## BCA Report

20-22 Atchison St  
St Leonards, NSW

Report No: 25056-102-R01 BCA Report  
Revision: 02  
Date: 22 September 2025

Ref: 25056-106-R01 BCA Report Rev02 Marked Plans  
 Reviewed by: Dishana Liang  
 Date: 22/09/2025

Drawing Title: **LEVEL 6 - 14 - RESIDENTIAL**

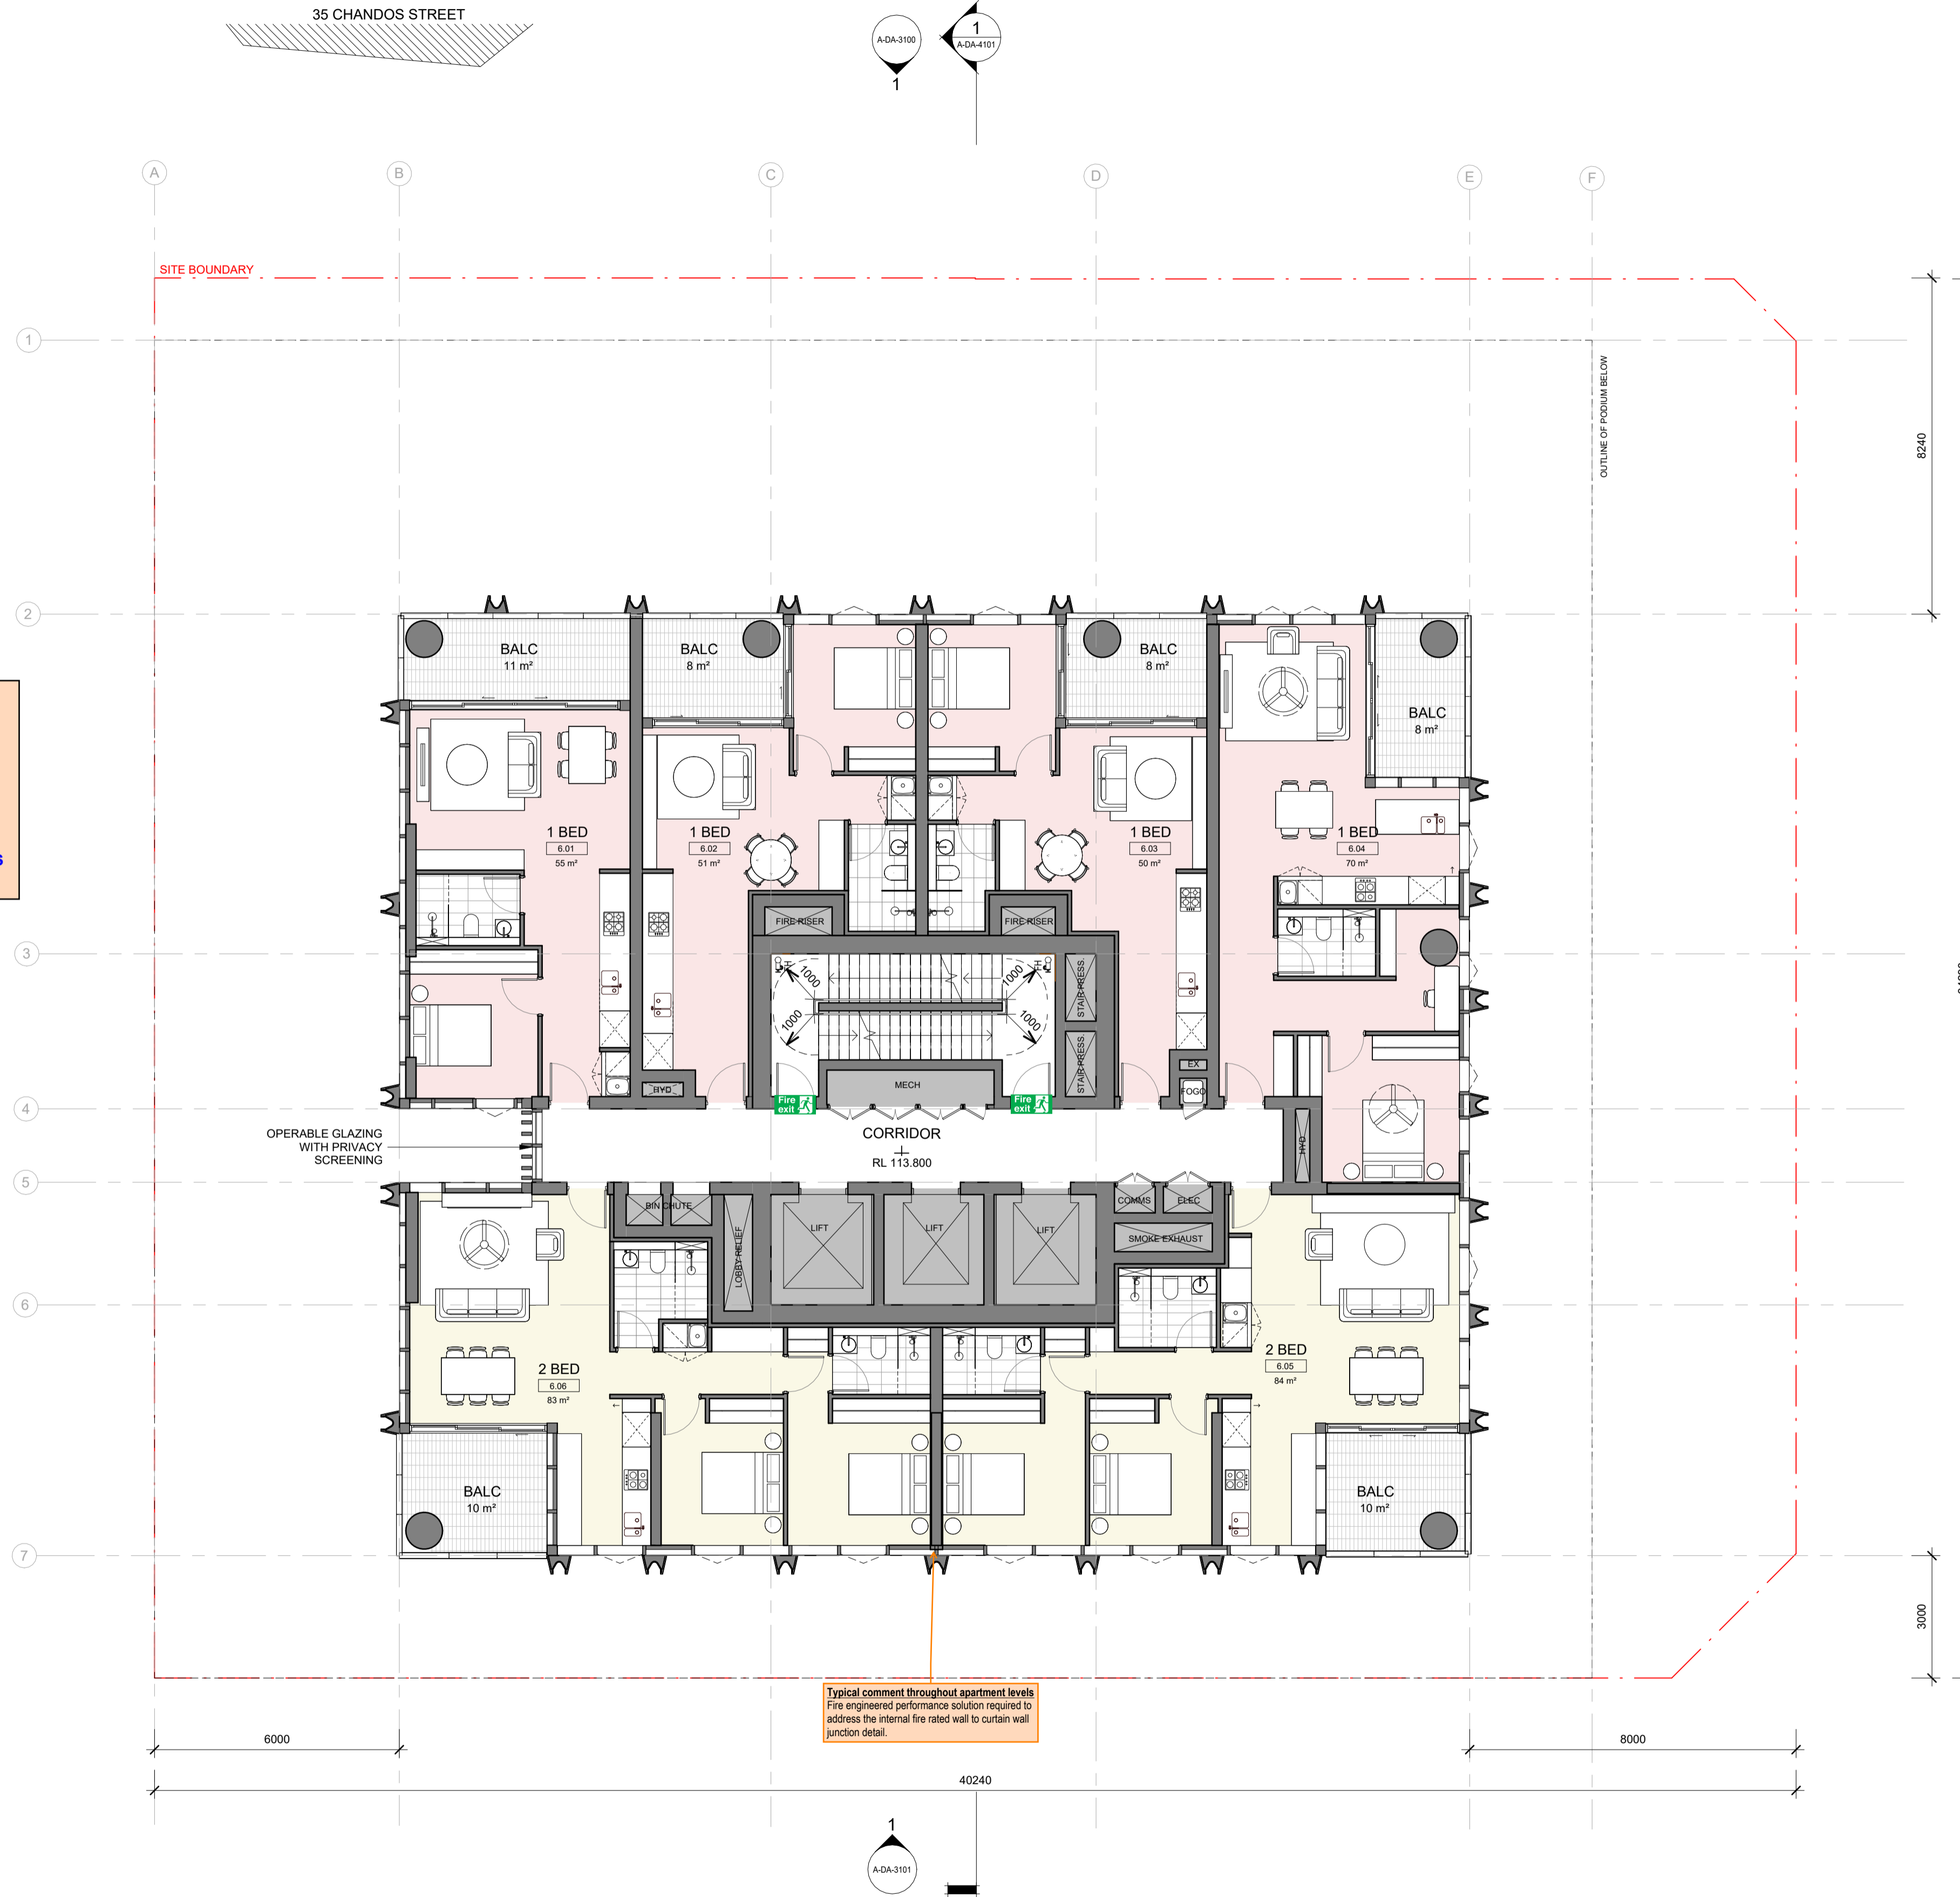
Typical comment throughout apartment levels  
Fire engineered performance solution required to address the internal fire rated wall to curtain wall junction detail.
